UNITED STATES PATENT AND TRADEMARK OFFICE

APPLICATION NO.	FILING DATE	FIRST NAMED INVENTOR	ATTORNEY DOCKET NO.	CONFIRMATION NO.
10/797,482	03/09/2004	Denise M. Demarais	19744P-000620US	3293

Office Action Summary	Application No. 10/797,482	Applicant(s) DEMARAIS ET AL.	
	Examiner Manuel A. Mendez	Art Unit 3763

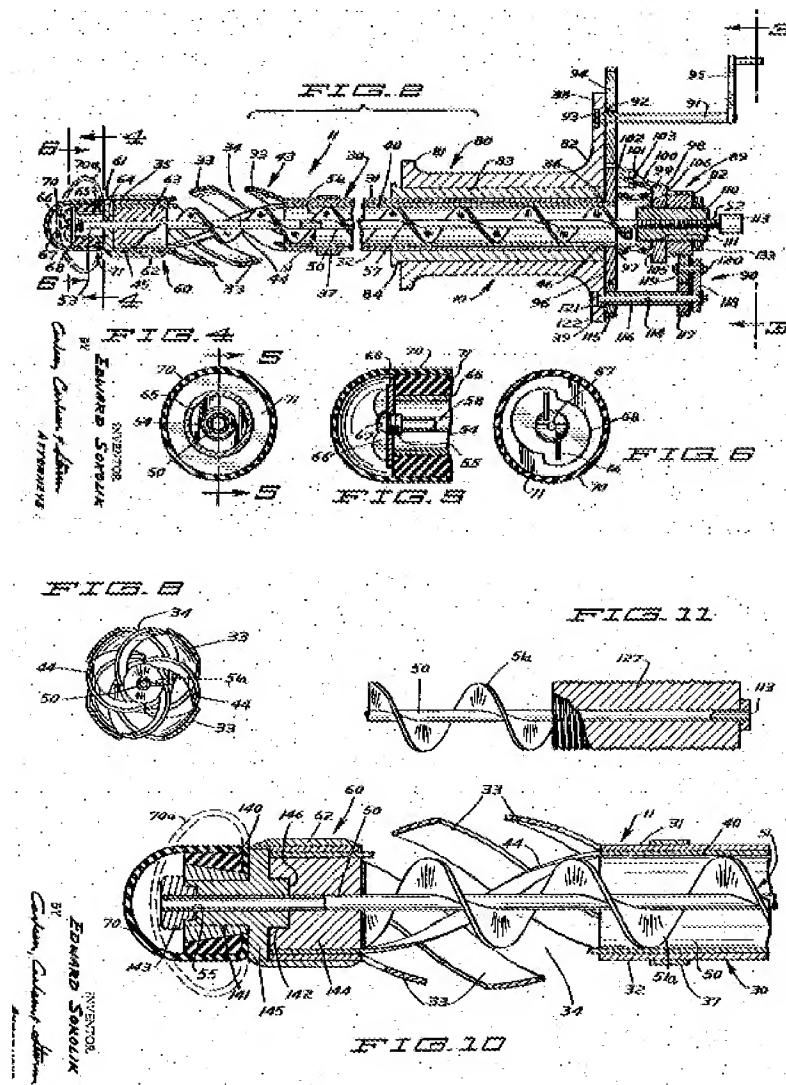
Claims 23-35 are rejected under 35 U.S.C. 102(b) as being anticipated by **Sokolik (US 3,320,957)**.

In the illustrative figures above, the Sokolik patent shows a circulation catheter having a catheter body, an impeller rotatably disposed in the lumen of the catheter body, and a clearing element.
